In response to the Office action mailed November 1, 2004, Applicant respectfully requests reconsideration, reexamination and allowance of claims 1-2 and 5-10 in view of the above amendments and the following remarks.

Amendments to the figures are shown on the appended sheet 4 of 21 (FIGS. 4 and 5) and sheet 16 of 21 (FIG. 23). In FIGS. 4 and 5, reference numeral 59 has been added and in FIG. 23 reference numeral 114 has been added. These sheets are annotated as replacements sheets.

Fig. 4

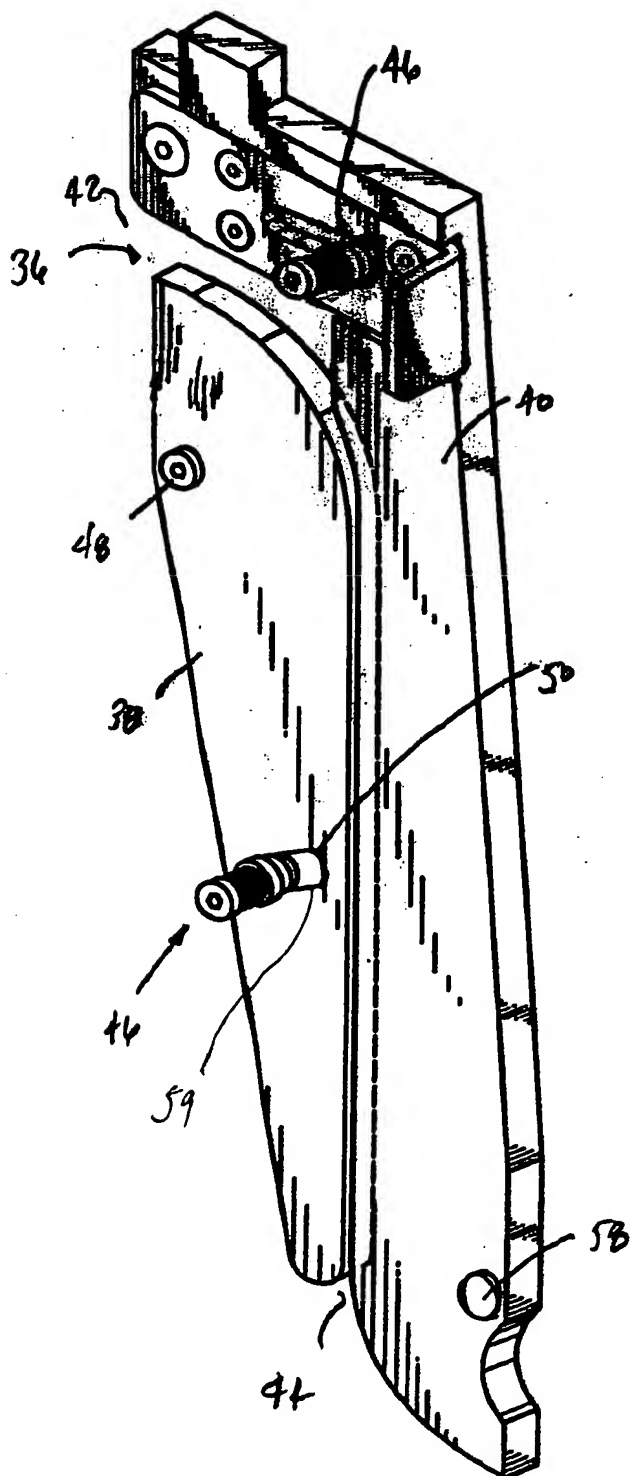
The Examiner has also objected to the use of reference character 58 to indicate both the enlarged portion and the pivot pin. Applicant has, as noted above, amended the specification to change enlarged portion to reference number 59 and has amended FIGS. 4 and 5 accordingly. Applicant respectfully submits that this objection has now been fully addressed and that it be withdrawn.
